Re: Petition No. 1558 - Community Power Group LLC petition for a declaratory ruling, pursuant to Connecticut General Statutes §4-176 and §16-50k, for the proposed construction, maintenance and operation of a 4-megawatt AC solar photovoltaic electric generating facility located at 24 Middle Road, Ellington, Connecticut, and associated electrical interconnection.

Enclosed for filing with the Connecticut Siting Council ("Council") are Community Power Group LLC's ("CPG" or the "Company") responses to the Council's first set of interrogatories dated March 3, 2023.

Community Power Group, LLC
Petition No. 1558

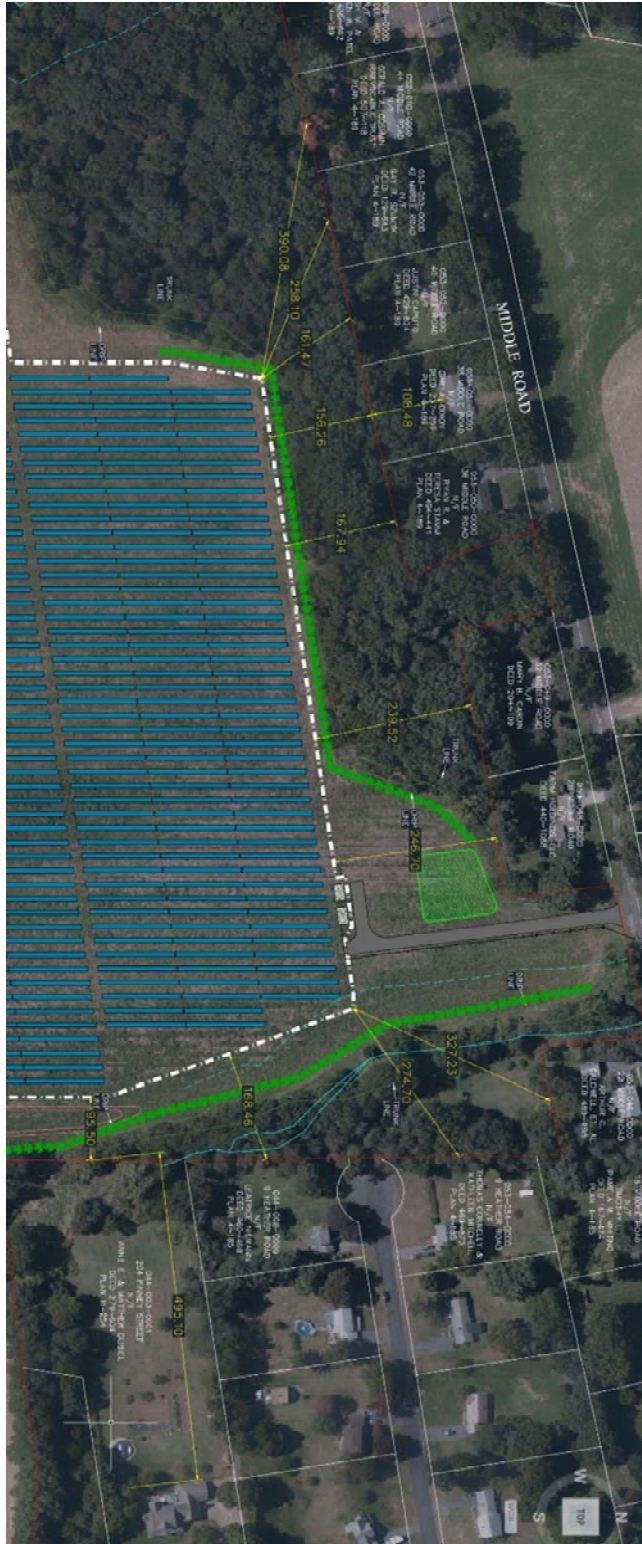
Q-CSC 1-11: Petition pp. 16-17 states the nearest residence is 250 feet from the solar facility. Provide an address and direction for this residence. What is the distance and direction from the solar facility perimeter fence to the nearest property line? What is the address of this property?

A-CSC 1-11: Please see the below diagram. The address of the nearest residence to the solar perimeter fence is 38 Middle Road, which is located on the northwest perimeter of the facility. The distance and direction for the nearest property line to the solar facility perimeter fence is on the eastern side of the facility (204 Pinney Street) and it is 95.5 feet.

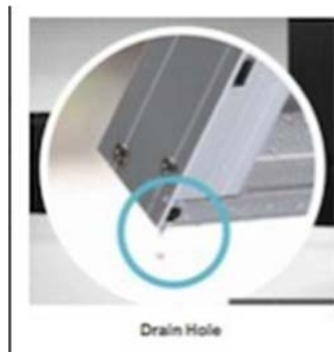
Q-CSC 1-46: Referring to Petition Exhibit N on p. 13 under “Panel Washing,” the first bullet references a panel “weep hole.” Explain.

A-CSC 1-46: “Weep holes” or drain holes are small holes in the bottom corner of a solar panel installed to help drain any condensation from inside of the panel structure. Please see the below picture.

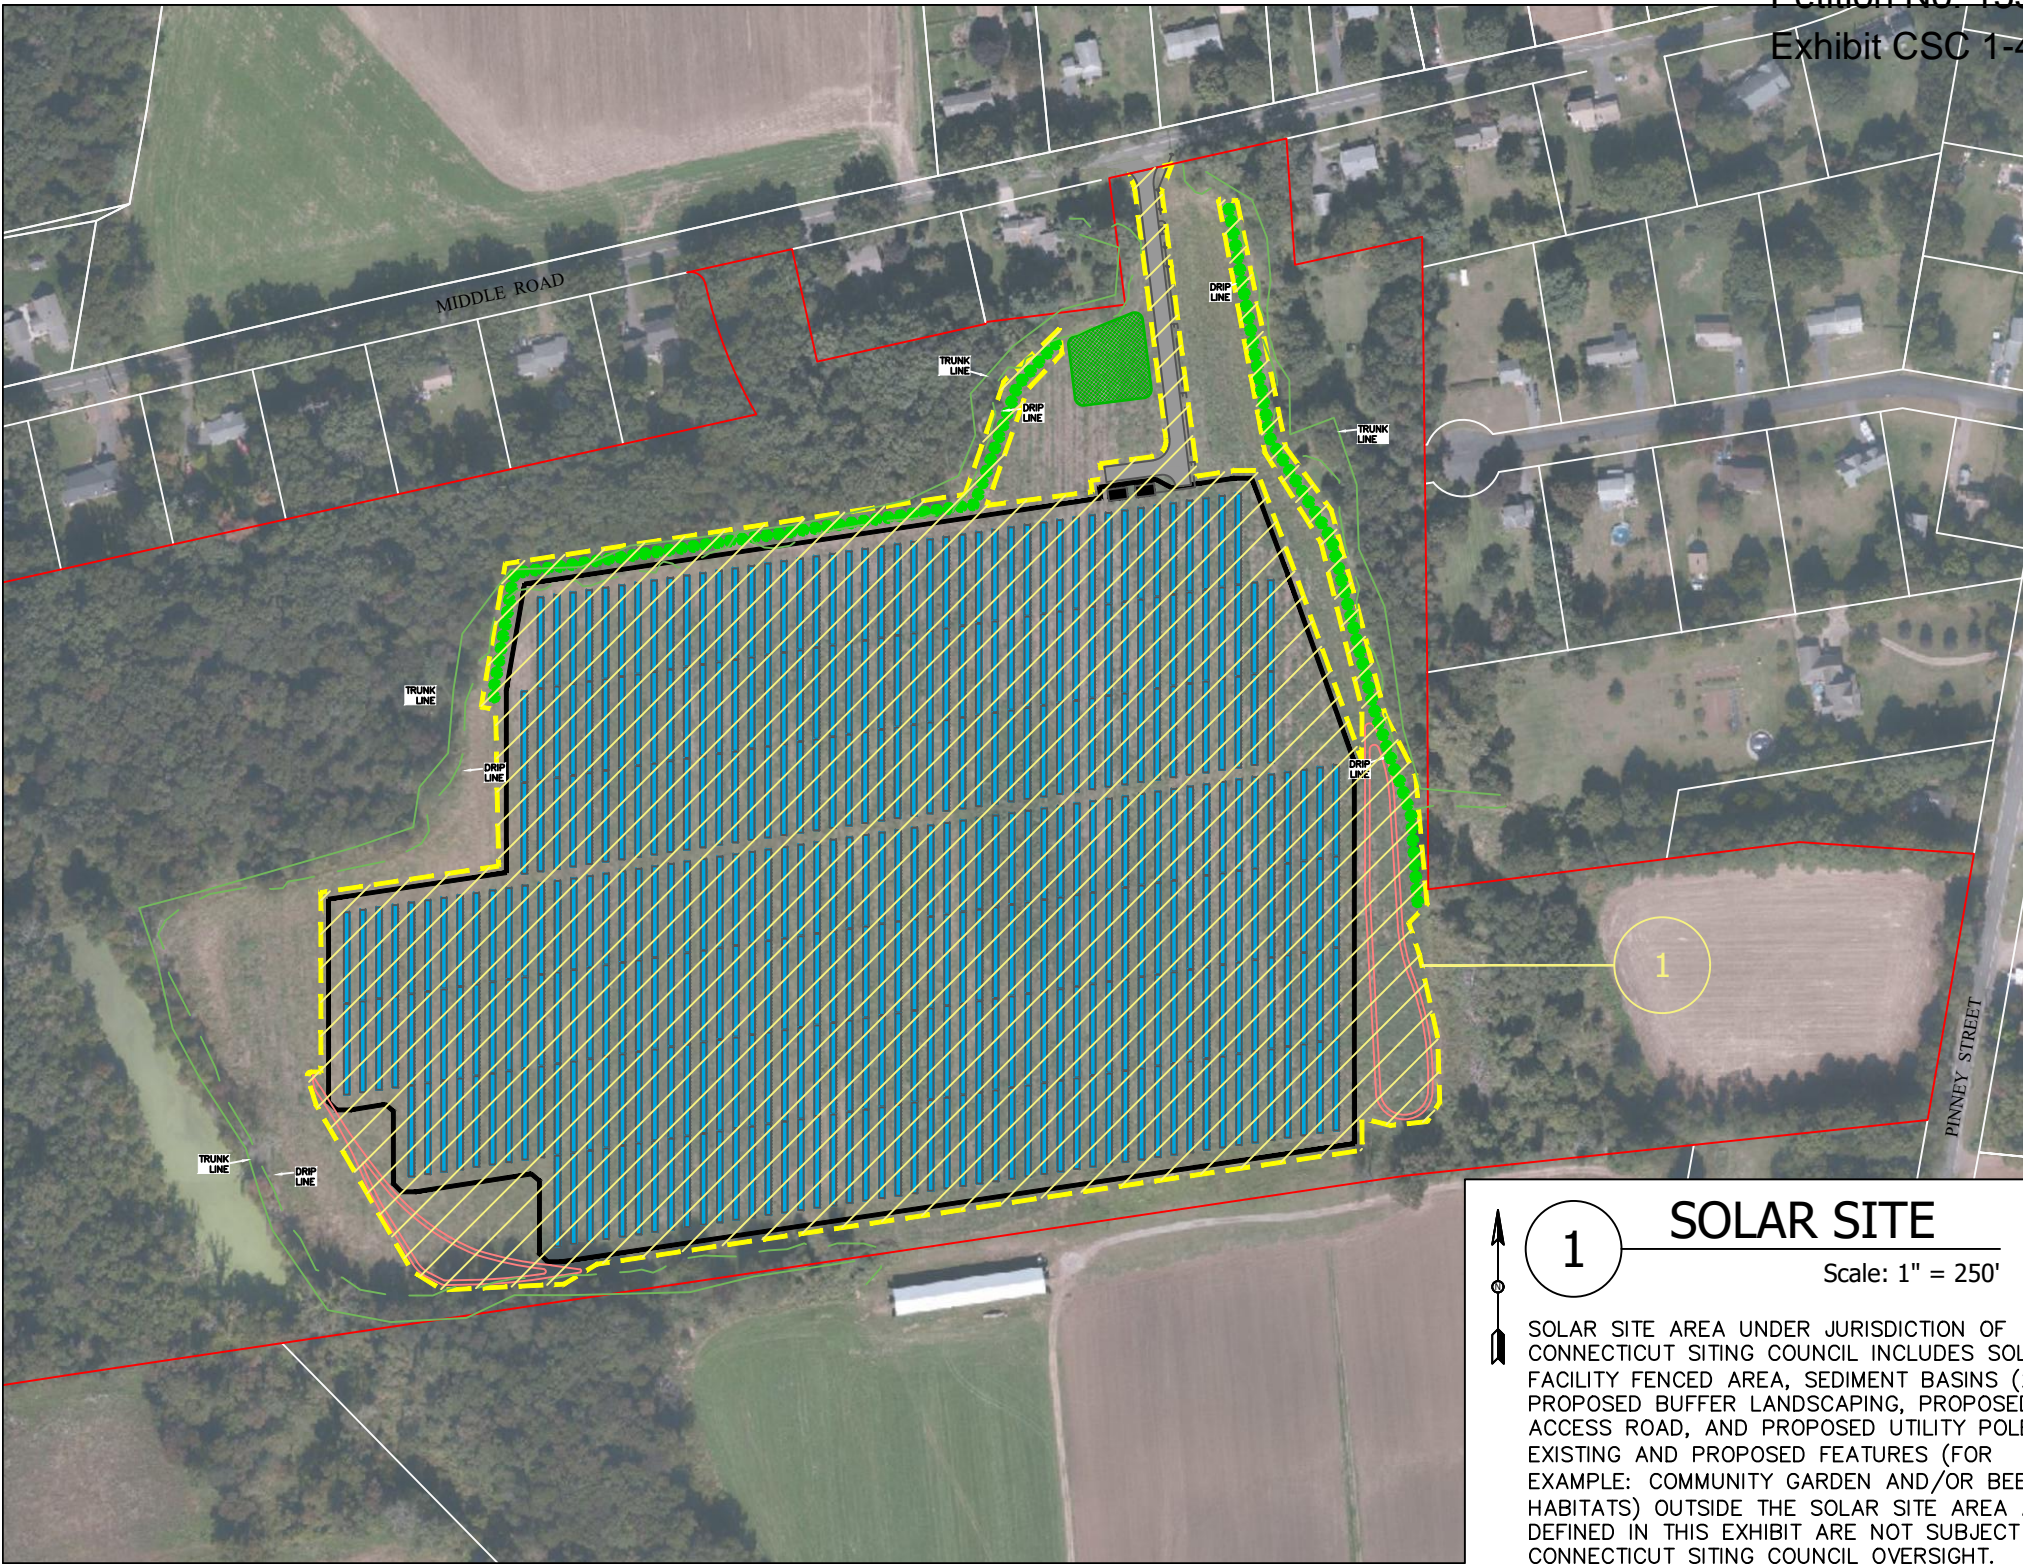
Q-CSC 1-30: Describe the anticipated views of the facility from the property at 204 Pinney Street. Can evergreens be planted along this property line to provide or improve screening of the facility?

A-CSC 1-30: Please see below for a visualization of the anticipated view of the solar facility and proposed screening from the property at 204 Pinney Street that was provided to the owners of such property by email on March 2, 2023. After the screening trees reach maturity, the view of the proposed facility from 204 Pinney Street is expected to be minimal. Please see Exhibit CSC 1-5-1 for the proposed landscape plan showing the proposed screening trees to be established between the facility and 204 Pinney Street.

24 MIDDLE SOLAR - LANDSCAPE EXHIBIT
N.T.S.

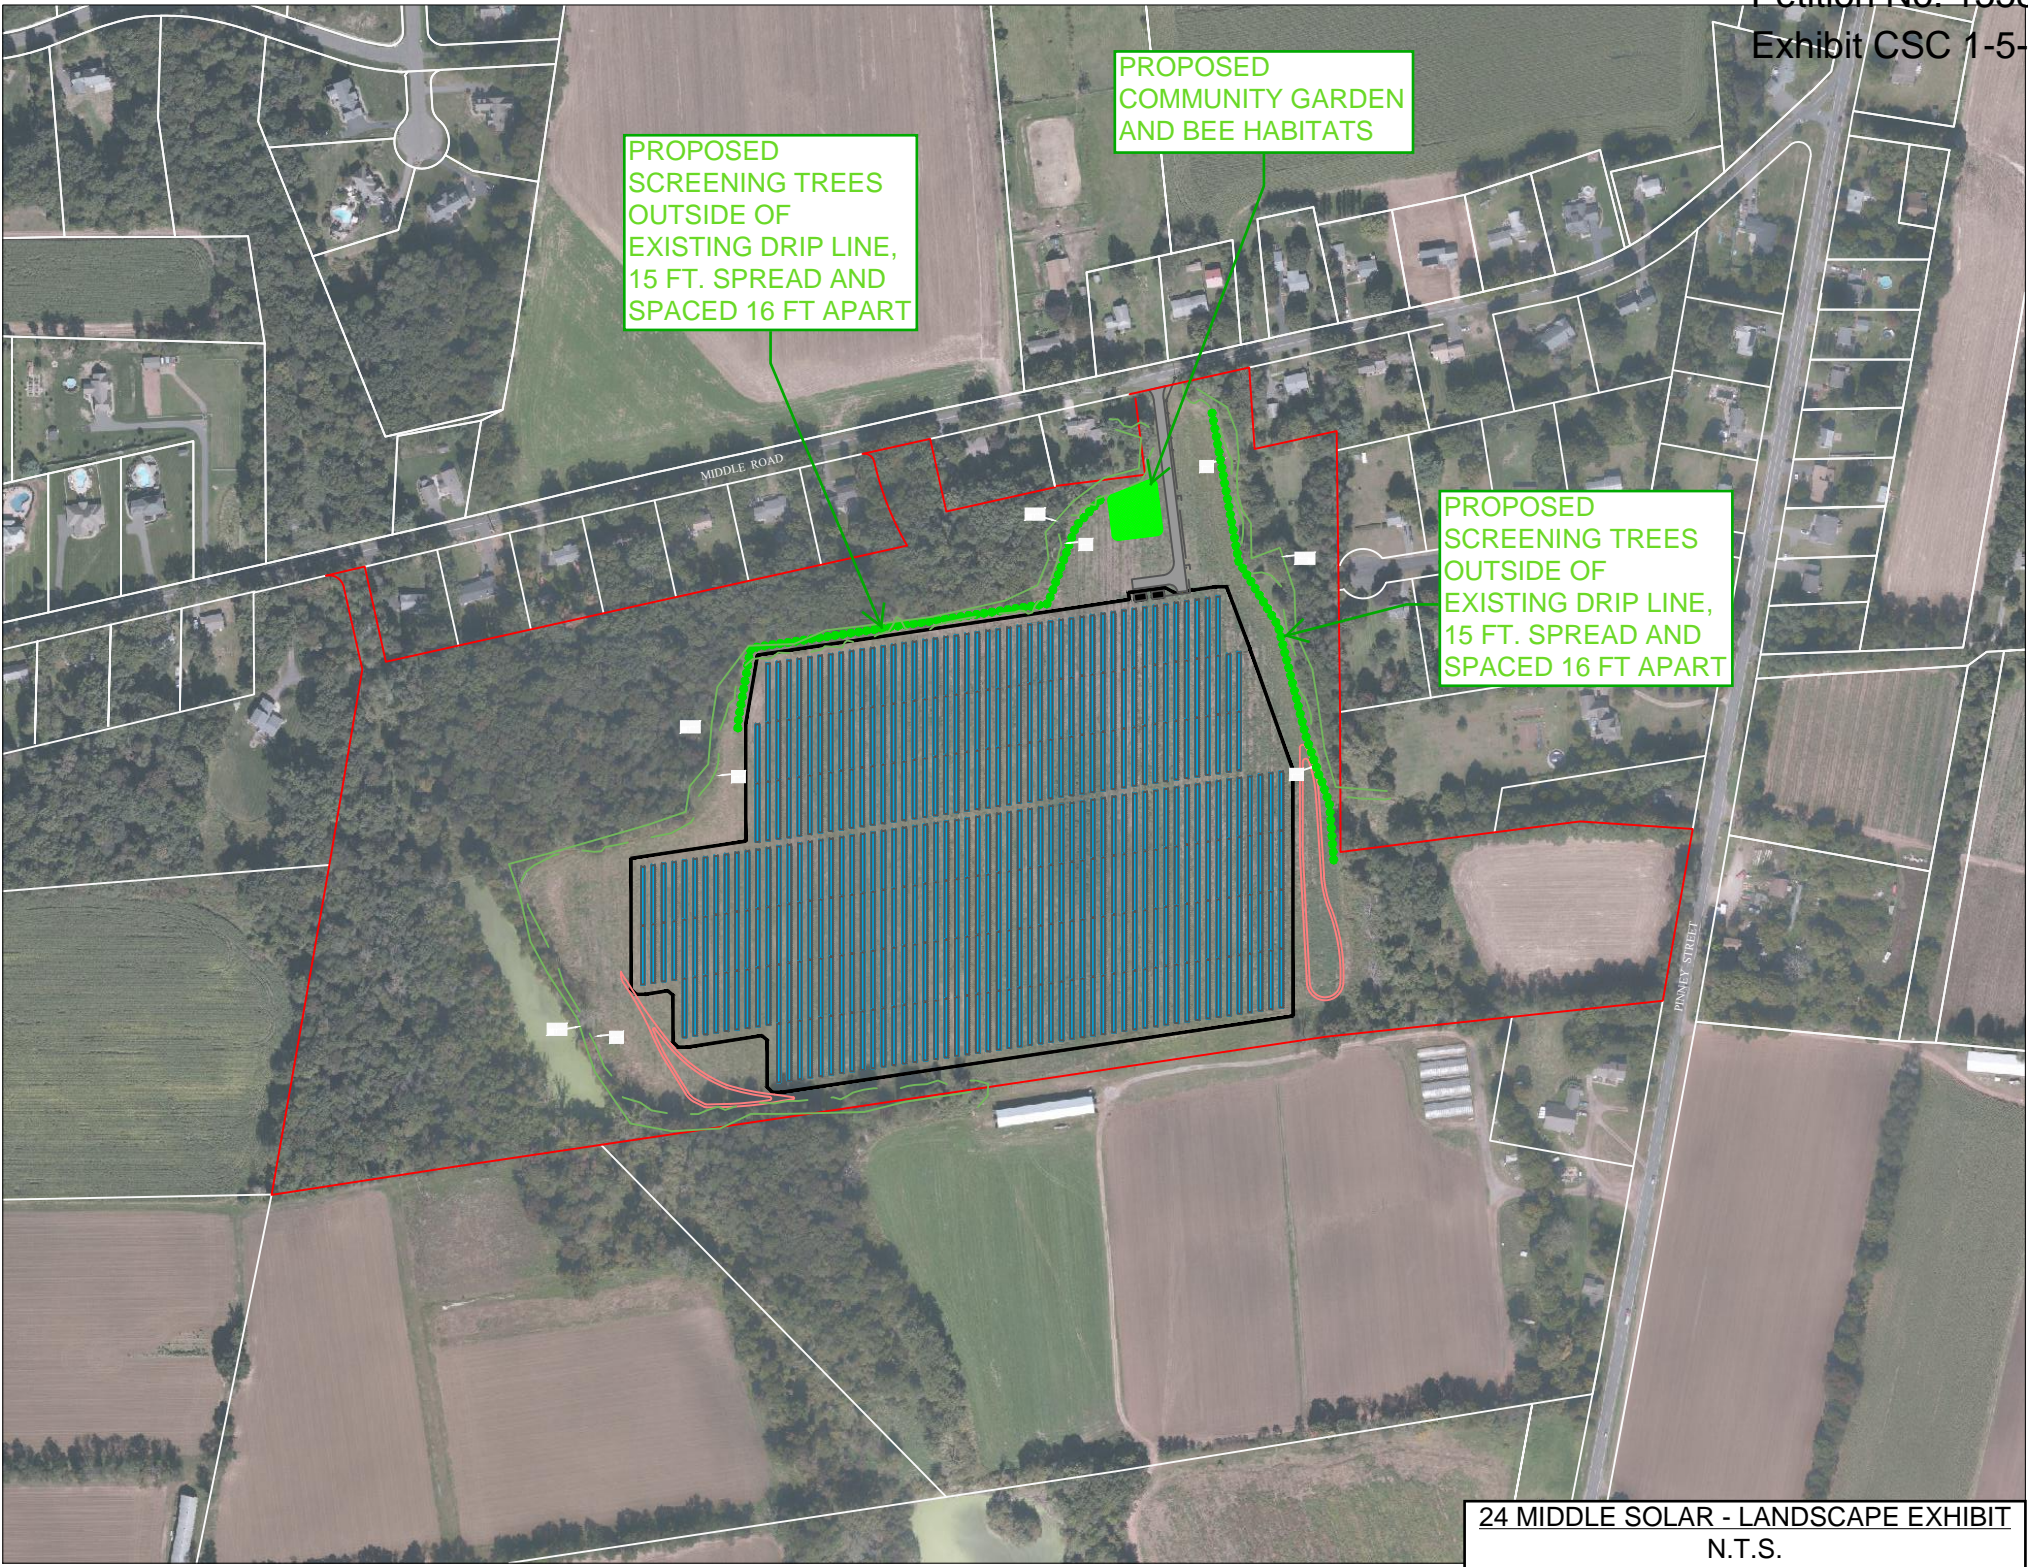
Q-CSC 1-33: Characterize year-round and seasonal views of the facility from abutting residential properties. What type of visual mitigation could be implemented for the site?

A-CSC 1-33: Please see Exhibit CSC 1-5-1 for the proposed landscaping plan. The visual impact from the proposed project will vary seasonally for the abutting residential properties to the east of the project site due to the quality and density of vegetation surrounding the project site. During the summer months, the properties to the east of the project site will have a largely diminished view of the project site due to the existing vegetation, in conjunction with installed screening trees. During winter months, for the neighboring properties to the east of the project site there is the possibility of viewing the project site due to the largely deciduous trees between the project site and the homes. However, the installation of CPG's screening trees will also greatly diminish this viewing possibility. For the properties to the north of the site along Middle Road, the potential visual impact of the project will be minimal throughout the year due to the dense existing vegetation which will be enhanced by additional installed screening.

PROPOSED
SCREENING TREES
OUTSIDE OF
EXISTING DRIP LINE,
15 FT. SPREAD AND
SPACED 16 FT APART

PROPOSED
SCREENING TREES
OUTSIDE OF
EXISTING DRIP LINE,
15 FT. SPREAD AND
SPACED 16 FT APART
